RHODE ISLAND CONTRACT NO.2017-CB-070

**Horton Farm Bridge No. 472**

**NOTICE TO PROSPECTIVE BIDDERS**

ADDENDUM NO. 5    Prospective bidders and all concerned are hereby notified of the following changes in the Plans, Specifications, Proposal and Distribution of Quantities for this contract. These changes shall be incorporated in the Plans, Specifications, Proposal and Distribution of Quantities, and shall become an integral part of the Contract Documents.

NORTH ABUTMENT  
DEMOLITION

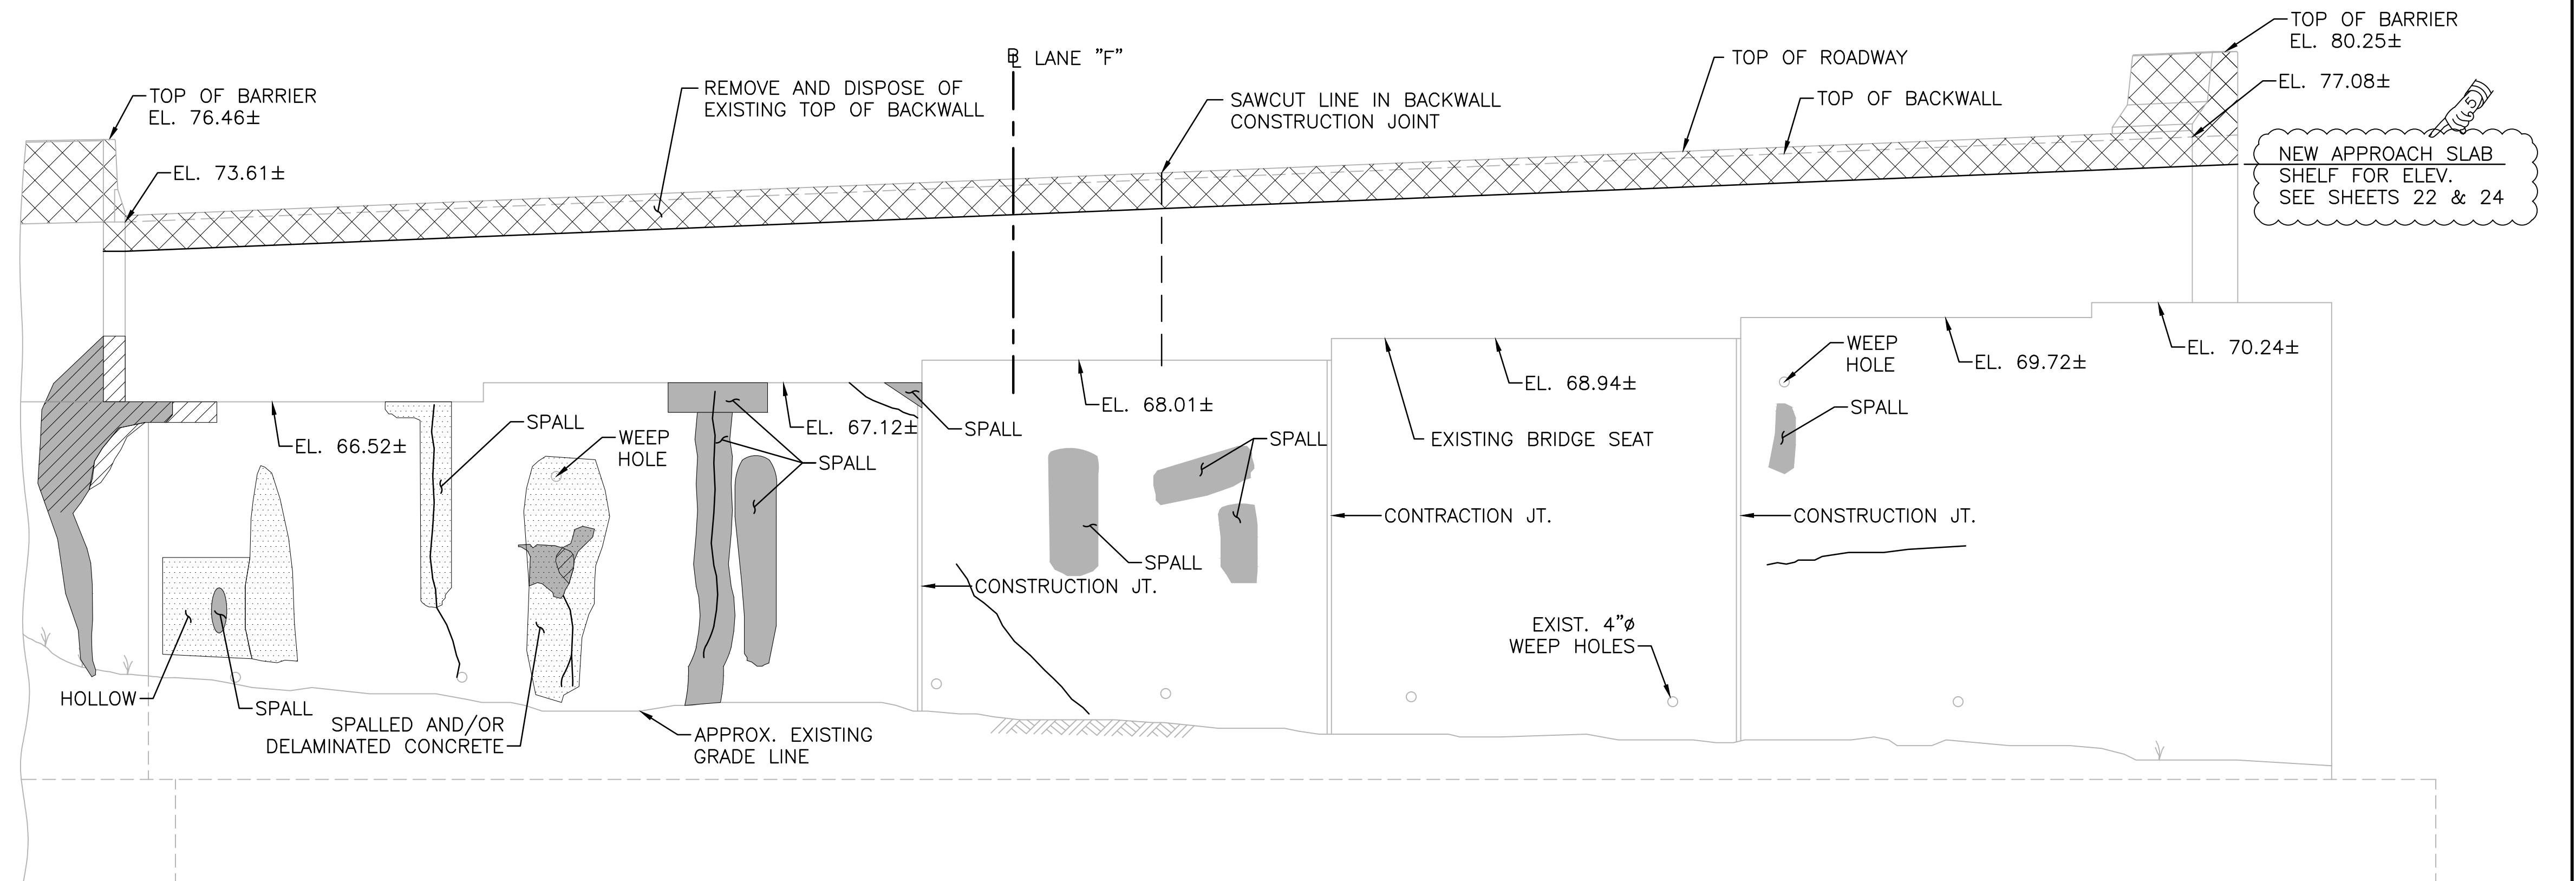
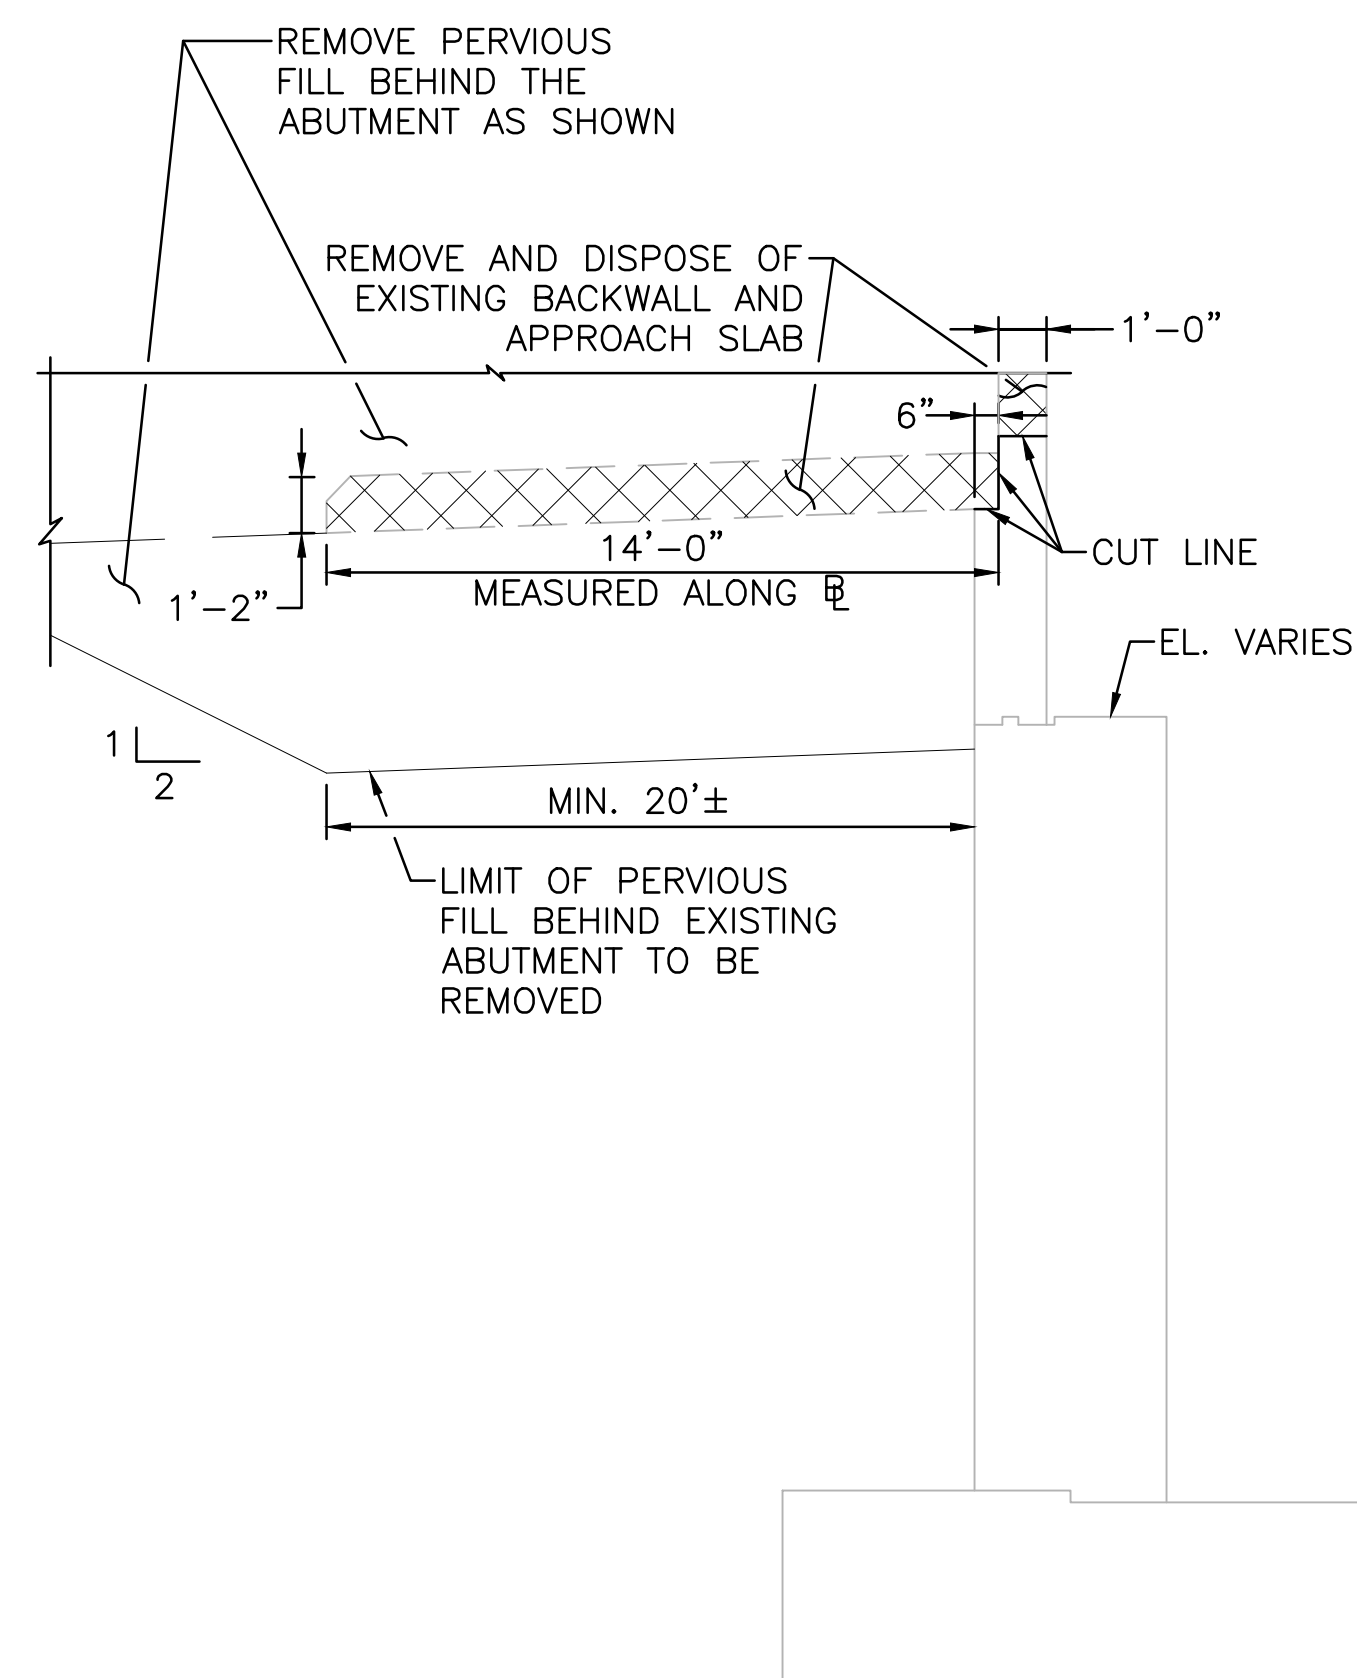
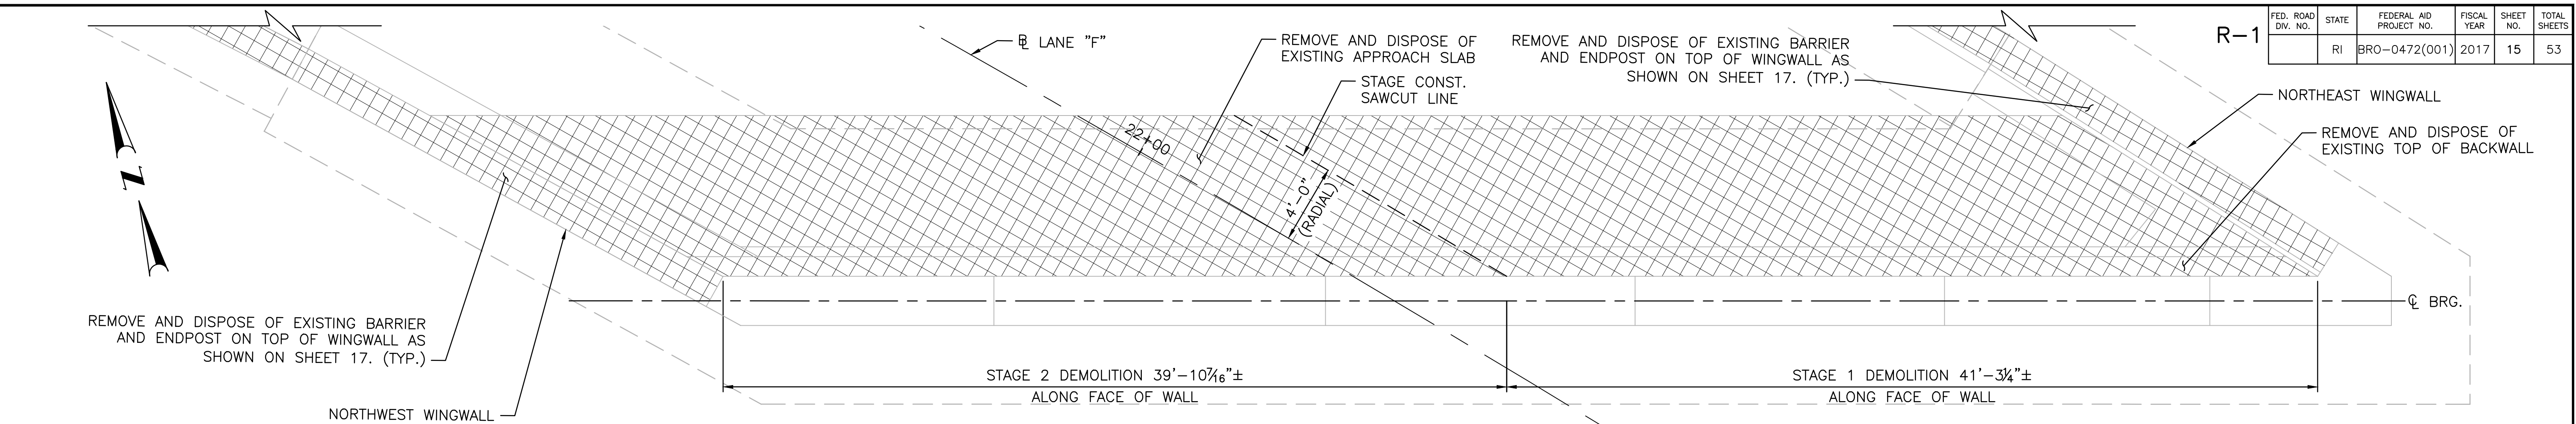
1.    VOLUME 2 SHEET 15 - NORTH ABUTMENT DEMOLITION  
Remove and replace Sheet 15 in its entirety with Sheet 15(R-1) attached to this Addendum No. 5. This sheet has been revised.
2.    VOLUME 2 SHEET 16 - SOUTH ABUTMENT DEMOLITION  
Remove and replace Sheet 16 in its entirety with Sheet 16(R-1) attached to this Addendum No. 5. This sheet has been revised.
